**Closure Plan, Rev. 4**  
**Tanners Creek Fly Ash Pond**

RE: **Tanners Creek Fly Ash Pond Capping/Closure Plan  
Response to Comments**

Reference: Responses to IDEM 12/3/18 RAI  
Fly Ash Pond Closure, Tanners Creek

*Figure 1: Cross-Section Through Fly Ash Pond and Borrow Area*

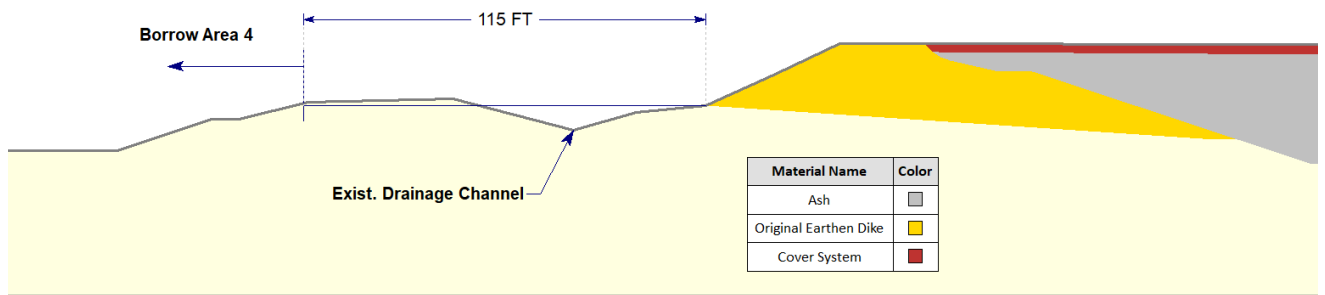
- c. Describe the procedures for excavating and back filling Borrow Area 4 that is adjacent to the Fly Ash Pond. Discuss how these construction activities will not de-stabilize the Fly Ash Pond, and how the stability of the Fly Ash Pond will be maintained since the Borrow Area 4 is in the 100-year flood plain. Also, excavation and filling of the borrow area may need additional approvals from other state and local agencies, such as the Indiana Department of Natural Resources.

*Response: A discussion of the Borrow Area Plan, prepared by others, has been added to the Closure Plan Narrative. See Section 5.10 – Borrow Area Plan. The borrow excavation will be wholly separate from the FAP Dikes and the excavation will not adversely impact FAP stability. Figure 1 below is a cross-section through the FAP and Borrow Area, which depicts the separation between the two areas. The bottom of the borrow excavation will be graded to drain but the excavation will not be re-filled and will impound water when the River floods. Any permit required for the borrow area will be obtained prior to excavation. The Erosion and Sediment Control Plan (by Stantec, 2017) depicts the proposed excavation grading. The drawings from this Plan have been included in the Subsurface Data Report (Attachment VI).*
